49 CFR Part 571

[Docket No. NHTSA-2009-0190]

Federal Motor Vehicle Safety Standards; Bus Emergency Exits and Window Retention and Release

ACTION: Notice of proposed rulemaking (NPRM).

Figure 3D- REAR EMERGENCY EXIT WITHOUT REAR OBSTRUCTION

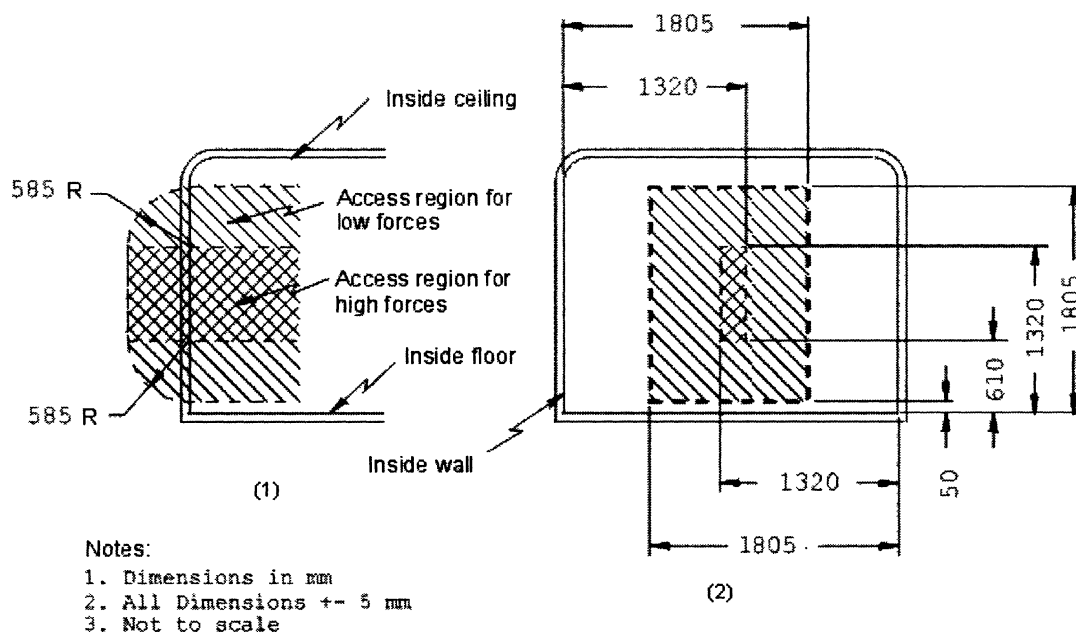
The School Bus Manufacturers’ Technical Council (SBMTC) petitioned the agency to amend FMVSS No. 217 to specify that the exterior release (handle) for school bus rear emergency exit doors may be located near the edge of the door on the side opposite the hinges. Specifically, SBMTC petitioned to amend S5.3.3.1(a) and one of the two drawings in Figure 3D.

S5.3.3.1(a) specifies that the manual interior and outside releases (handles) are located: “Within the high force access region shown in Figure 3A for a side emergency exit door, and in figure 3D for a rear emergency exit door.” Figure 3D consists of two drawings. The left-side drawing shows the vertical dimensions of the high force access region. As shown in the left-side drawing, the release (handle) may be located at any point from the left side of the door to the right. However, the right-side drawing, giving a different perspective of the rear exit, shows that the high force access region is a narrow area in the center of the door. Since S5.3.3.1(a) requires the interior and exterior releases (handles) to be “[w]ithin the high force access region shown in * * * figure 3D for a rear emergency exit door,” the releases must be in that narrow area in the center of the door shown in the right-side drawing of Figure 3D. As noted earlier, in actuality, SBMTC stated that manufacturers are “universally” placing the exterior releases on the side of the doors opposite the hinges.

SBMTC suggests that we reconcile the language of the standard with the practices of the industry and with what petitioner believes is best for safety. The petitioner suggests that we make the right-side drawing of Figure 3D apply only to the interior release (handle) and not to the exterior release. With regard to applying the right-side drawing to the interior release (handle), the petitioner believes there are reasons to require the interior release to be in the center of the door: the location ensures that the release is visible to bus occupants, and is not obscured by seat backs if the door is wider than the bus’s center aisle. Further, we note that the exit would be opened by a pushing rather than pulling

NHTSA agrees. We propose amending the standard to specify that the interior release (handle) for a rear emergency exit must be in the high force access region shown in both drawings of current Figure 3D, and that the exterior release for the exit must only be in the high force access region shown in the left-side drawing of current Figure 3D. Although no manufacturer currently places the exterior release in the center of the door, we request comment on whether we should require the exterior release to be no further than two inches away from the edge of the door. (To clarify the standard, NHTSA proposes that instead of having Figure 3D consist of two drawings, Figure 3D would be easier to understand if the left-side drawing were renamed Figure 3D(1) and the right-side drawing were renamed Figure 3D(2).) We tentatively agree that the school bus manufacturers' current practice of placing the exterior rear emergency exit door release (handle) near the edge of the door on the side opposite the hinges better meets the need for safety than placing the exterior release in the center of the door. Releases (handles) placed opposite the hinges would require less force to pull open the door for persons outside the school bus.

(a) *Location:* Within the high force access region shown in Figure 3A for a side emergency exit door, within the high force access region shown in both Figure 3D(1) and Figure 3D(2) for an interior release mechanism for a rear emergency exit door, and within the high force access region shown in Figure 3D(1) for an exterior release mechanism for a rear emergency exit door.
